## COUNCIL ASSESSMENT REPORT

<b>Panel Reference</b>	PPSSCC-37
<b>DA Number</b>	483/2020/JP
<b>LGA</b>	The Hills Shire Council
<b>Proposed Development</b>	Mixed Use Development
<b>Street Address</b>	Lot 129 DP 280036 Civic Way, Rouse Hill
<b>Applicant</b>	Combined Projects
<b>Consultant/s</b>	Group GSA Sutherland and Associates Planning Barker Ryan Stewart Scott Carver Australian Consulting Engineers Koikas Acoustics Pty Ltd Windtech Urbis Daw and Walton Consulting Surveyors Morris Goding Access Consulting Elephants Foot Recycling Solutions Affinity Fire Engineering Mondan Management Pty Ltd EI Australia
<b>Date of DA lodgement</b>	11 October 2019
<b>Number of Submissions</b>	First Notification: Three Second Notification: Four
<b>Recommendation</b>	Approval subject to conditions
<b>Regional Development Criteria (Schedule 7 of the SEPP (State and Regional Development) 2011</b>	CIV exceeding \$30 million (\$119,230,315)
<b>List of all relevant s4.15(1)(a) matters</b>	<ul style="list-style-type: none"> <li>• SEPP State and Regional Development 2011</li> <li>• SEPP 55 – Remediation of Land</li> <li>• SEPP Design Quality of Residential Flat Development</li> <li>• SREP 20 – Hawkesbury Ne

Figure 1 – Façade lengths of T5 and T6 as viewed from the north and west

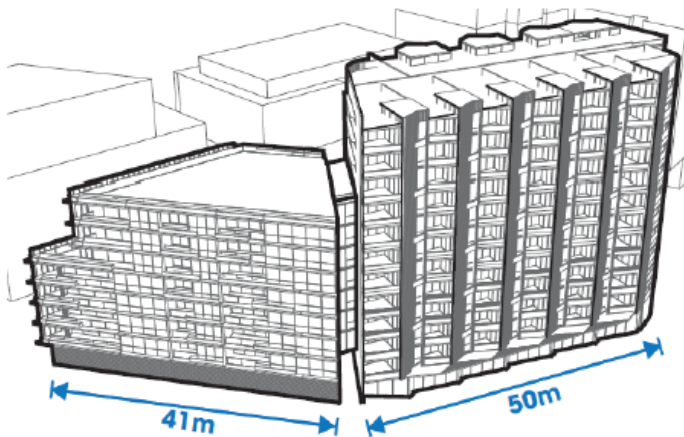
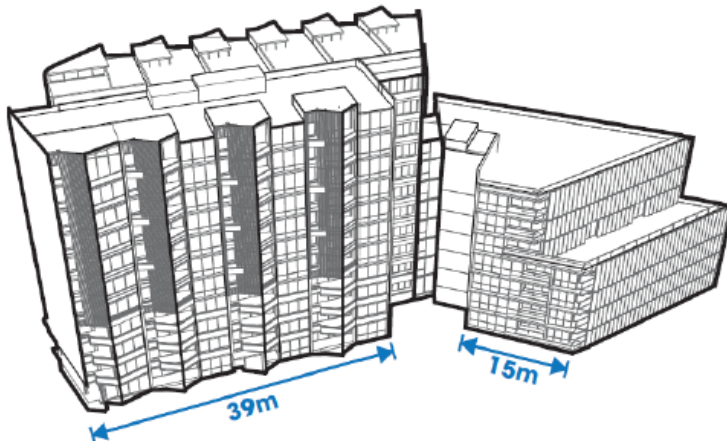
- The images below demonstrate that Buildings T5 and T6 are on significantly different angles from one another and are only joined by a slim and recessed connecting component, and each respective length of façade does not exceed 50 metres. Building T5 has a length of 41m and Building T6 has a length of 50m as viewed from the north and west (see Figure 1 below), and Building T5 has a length of 15m and Building T6 has a length of 39m as viewed from the south and east (see Figure 2 below), consistent with the intent of the control.

- Each building has a significantly different height with T5 being 7 storeys in height and T6 being 11 storeys in height, which also serves to distinguish each building from one another, but in addition also reduces the apparent scale and bulk noting that Building T5 is significantly below the maximum height control.

Having regard to the above, it is considered that whilst the overall combined length of Buildings T5 and T6 exceeds 50 metres, that the design of these buildings meets the intention of the control to control the apparent bulk and scale of buildings, avoid excessively long buildings with homogeneous architectural expression, and to achieve diversity of façade language and scale within a development. On this basis, the proposed variation to the maximum length control is demonstrated to have merit and is capable of support in this instance.
